Subject: **HIGH FLUTTER WHEN USING "EXT SRC" INPUT**

Model: **APR-5001/5002/5003**

Serial No: **20,201 AND HIGHER (APR-5001)**
20,201 AND HIGHER (APR-5002)
20,401 AND HIGHER (APR-5003)

Figure 1

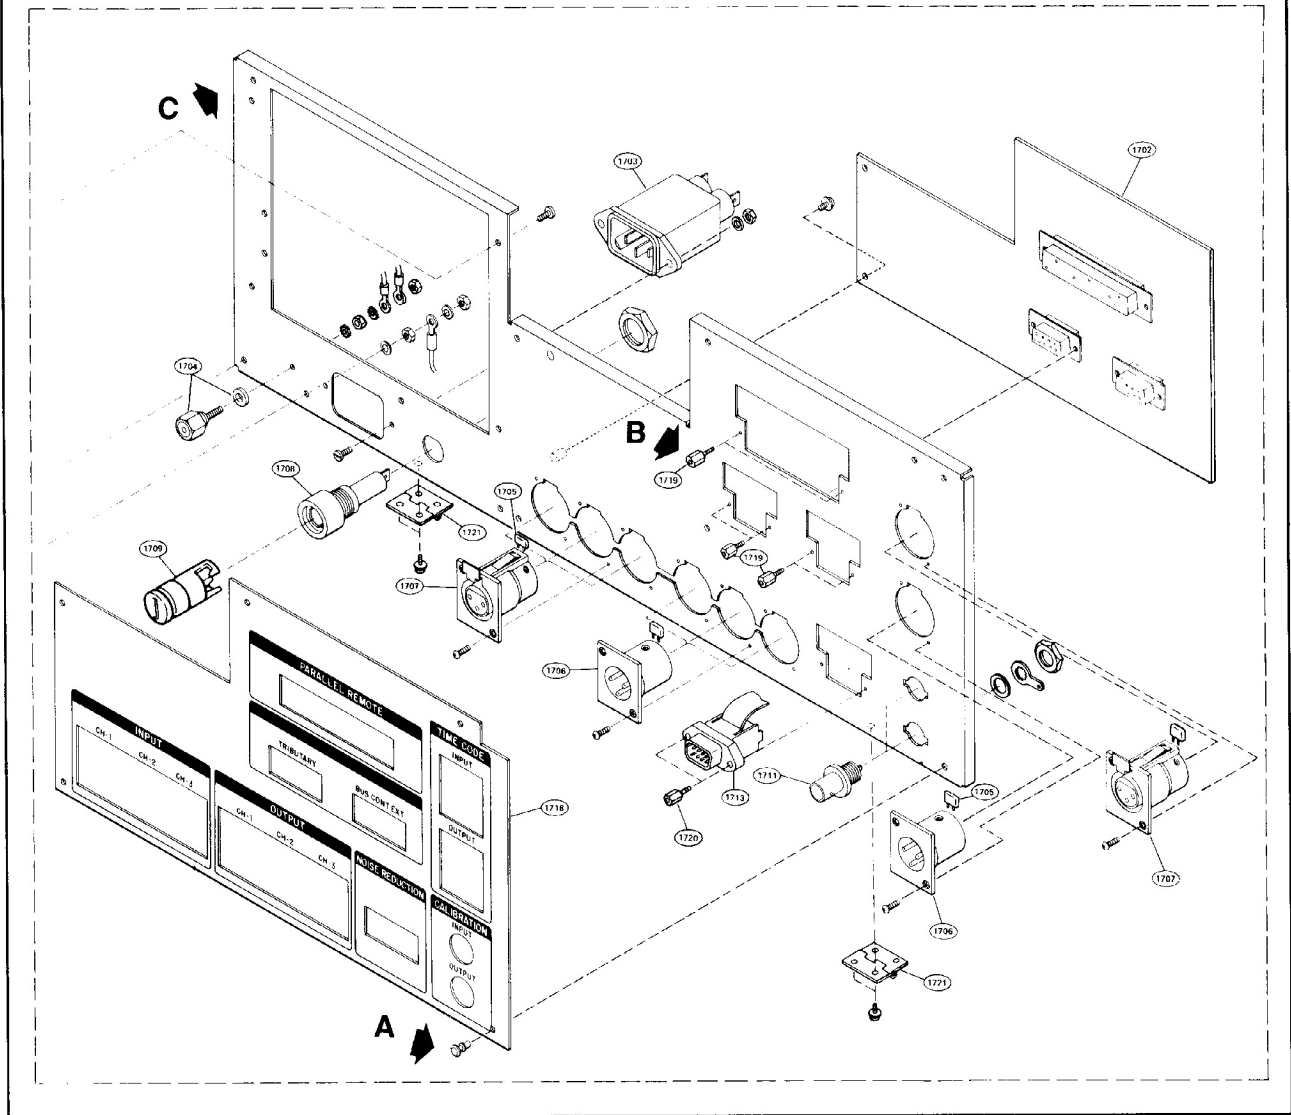
High flutter may occur when using the EXT SRC input. Flutter is caused by a slow rising edge on the output of IC7 on the CNX Board. To correct this problem, modify the CNX Board as described in the following procedure.

1. To access the CNX Board, first remove five pop-in fasteners on rear panel (A).
2. Remove hex screws (6) located on rear panel (B).

3. Open lower rear panel by removing screws (2) located in upper left- and right-hand corners (C). (See Figure 1.)
4. Remove CNX board by first removing screws (2) holding board in place (A). (See Figure 2.)
5. Push connectors out through cutouts so CNX Board can clear lip of outer panel when being lifted out.
6. If CNX board is numbered T-9412-316-1, it will have a 5-pin resistor network (RN1) instead of discrete resistors at R80 and R81. If so, remove IC7 (HCPL-2730) and replace with HCPL-2531 (T-9413-636-1). No resistor changes are needed.
7. If CNX board is numbered T-9412-316-2 through T-9412-316-4, or 1-619-162-11, proceed with steps a and b.
 - a. Remove IC7 (HCPL-2730) and replace with HCPL-2531 (T9413-636-1).
 - b. Remove R80 and R81 (470Ω) and replace with 4.7kΩ resistors.
8. Reinstall CNX Board by repeating steps 1 and 2 in reverse order.
